Planning & Zoning Commission

SUBJECT: Consider recommending approval of the site plan and preliminary plat for the construction of seven, 24-unit multi-family apartment buildings on Lots 1 and 2 of Adam Ridge Plat 3. The subject property is located south of NW 62nd Avenue between NW 103rd Street and NW 106th Street.

SITE PLAN / PRELIMINARY PLAT ADAM RIDGE PLAT 8 APARTMENTS JOHNSTON, IOWA

SITE PLAN / PRELIMINARY PLAT
ADAM RIDGE PLAT 8 APARTMENTS
JOHNSTON, IOWA
DIMENSION PLAN

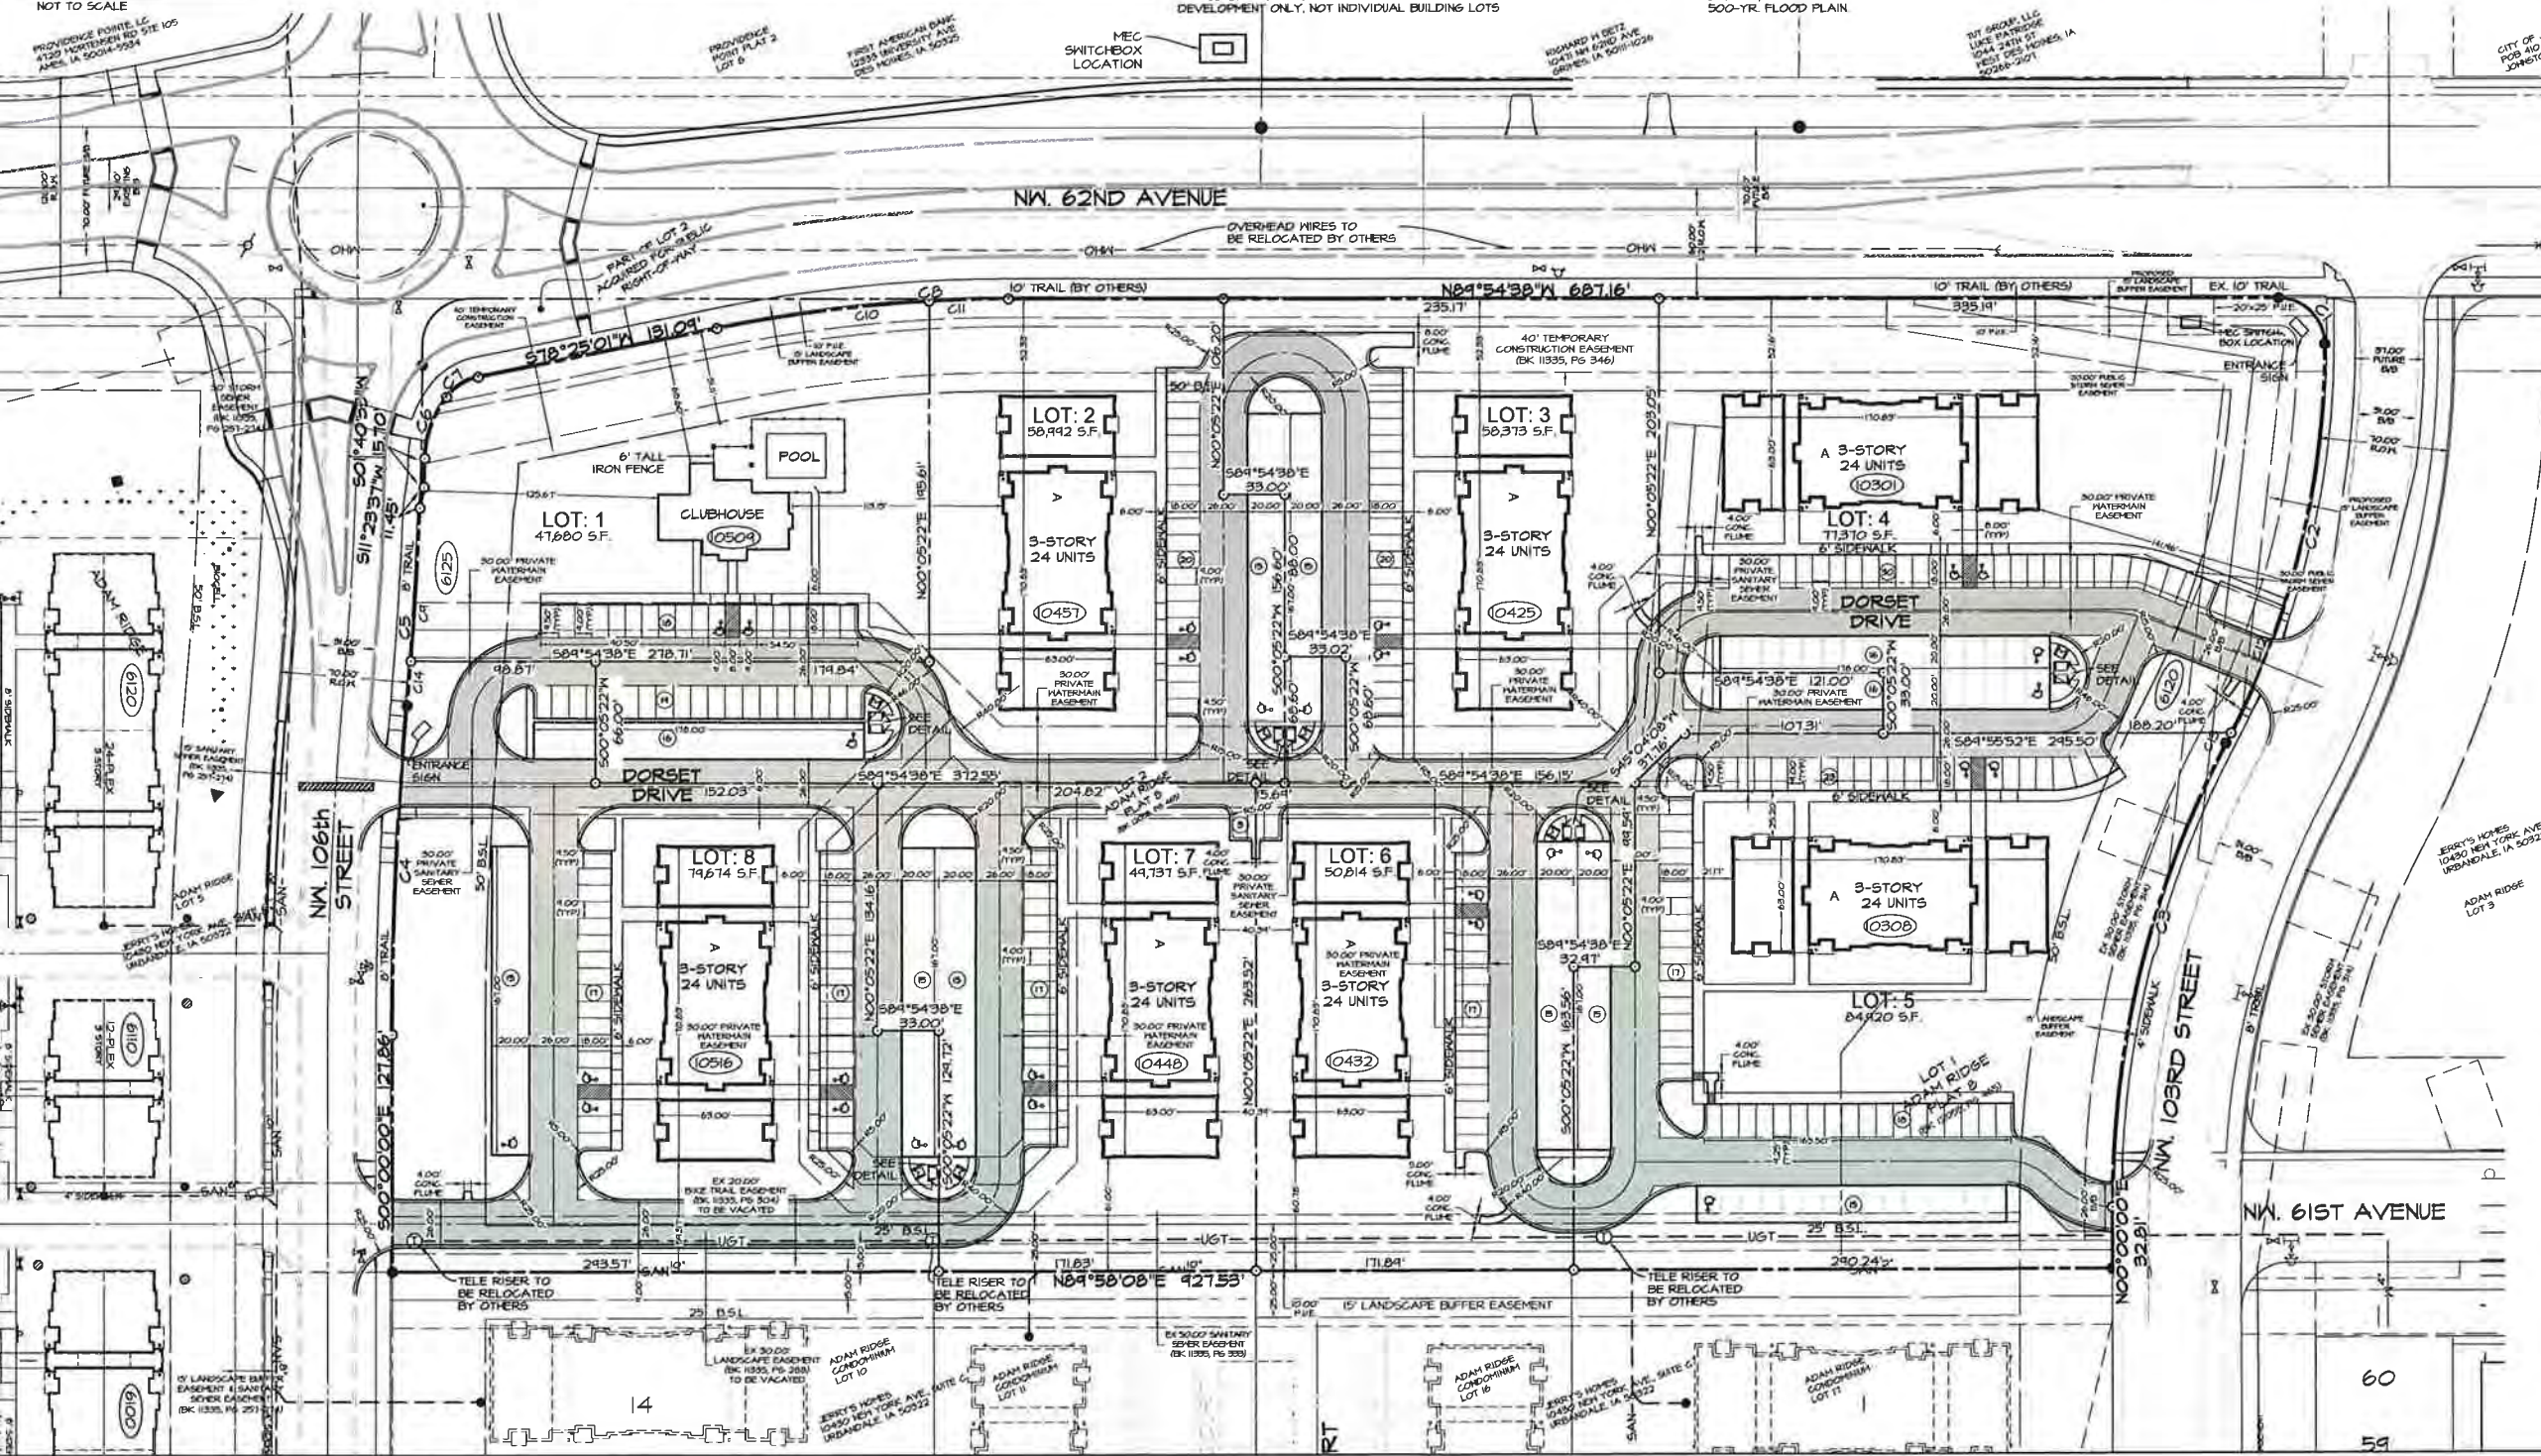
6. Identify the location of each building’s KNOX Box;
7. Reconcile the inconsistencies in the north buffer area between the

number of Viburnum listed in the plant schedule and the total number of shrubs provided (42 vs. 40).

8. Indicate the location for each building's fire department sprinkler connection, to be located within 100' of the closest hydrant and unobstructed by adjacent parking stalls;
 9. Revisions to satisfactorily address the review letter provided by Foth Infrastructure and Environment dated 8/5/14.
-

As illustrated above, both buffers are in compliance with the buffer landscaping requirements. However, there is a minor inconsistency with the north buffer area plant schedule. 42 Arrowhead Viburnum are listed in the plant schedule and the total number of shrubs is listed as 40. Staff recommends the applicant revise the north buffer plant schedule to reconcile the discrepancy between the number of Viburnum planted and total number of shrubs planted in the north buffer area (42 vs. 40).
